ADDENDUM NO. 1

GMIA – RUNWAY 1L-19R PAVEMENT RE-HABILITATION

PROJECT NO. A135-08017

DATE OF ADDENDUM: JANUARY 13, 2012

TEMPORARY SUPPORT PLAN FOR RUNWAY SAFETY AREA

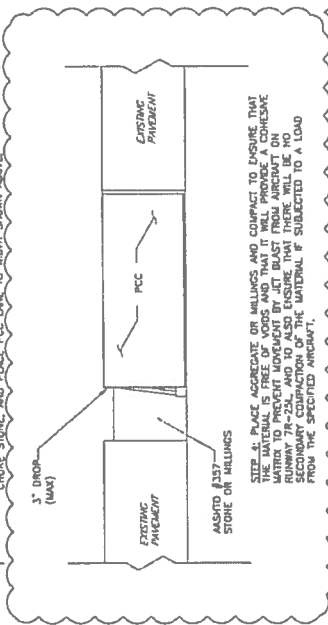
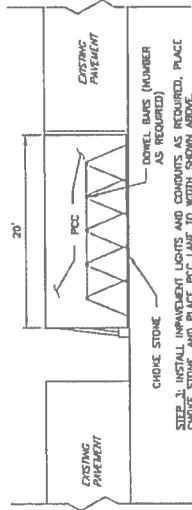
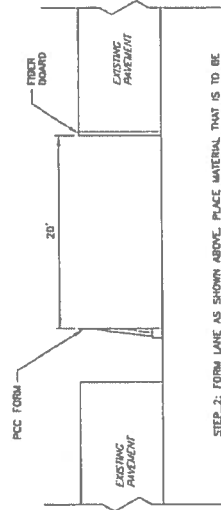
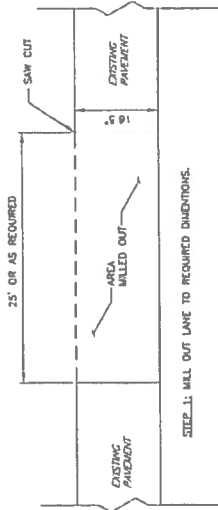
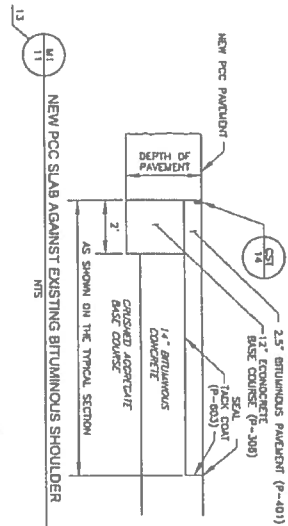
Sheet 10 of 32 Sequencing Details:

Delete sheet in its entirety and replace with the attached sheet 10 of 32 Sequencing Details.

M13 DOWEL BARS AT JOINT INTERSECTIONS
NTS

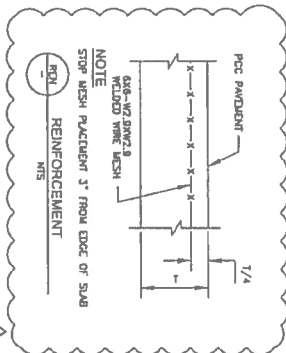
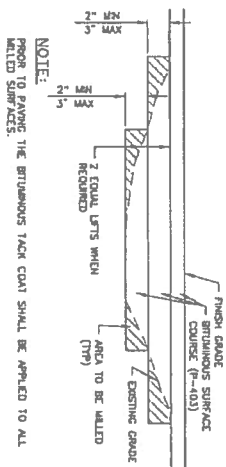
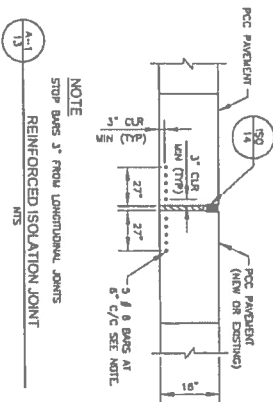
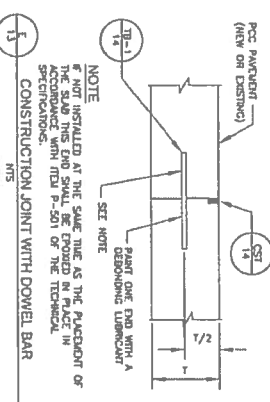
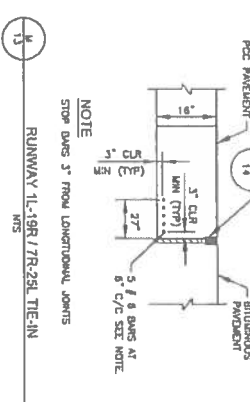
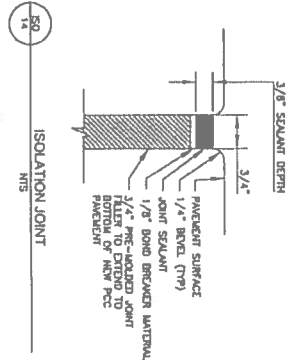
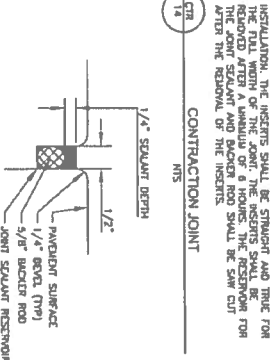
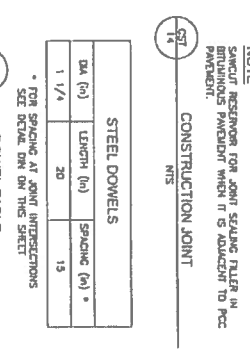
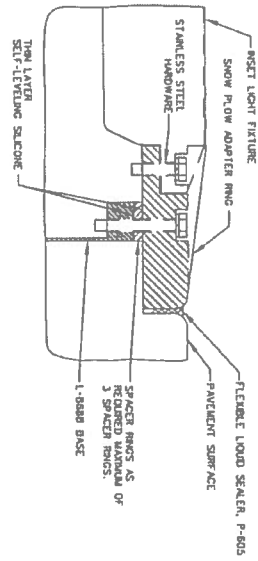
Sheet 14 of 32 Paving Details

Delete sheet in its entirety and replace with the attached sheet 14 of 32 Paving Details.

22/21 **LM**
LIGHT FIXTURE MOUNTING DETAIL
MTS

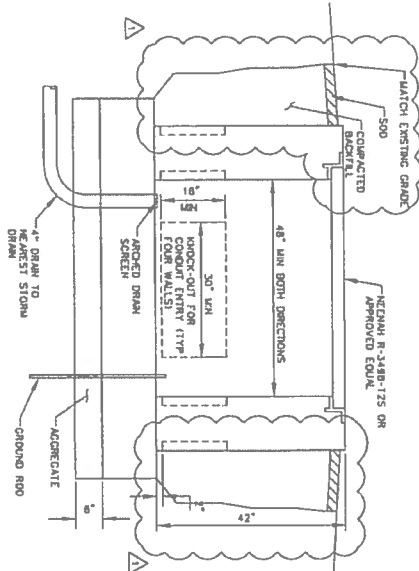
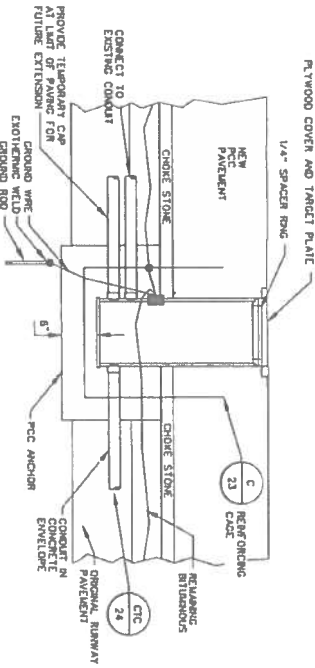
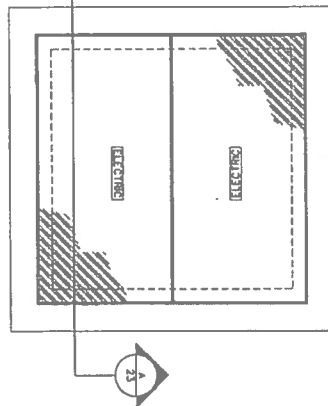
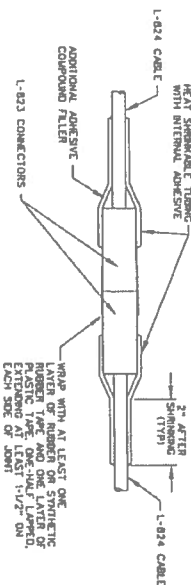
Sheet 23 of 32 Electrical Details Sheet 3:

Delete sheet in its entirety and replace with the attached sheet 23 of 32 Electrical Details Sheet 3.
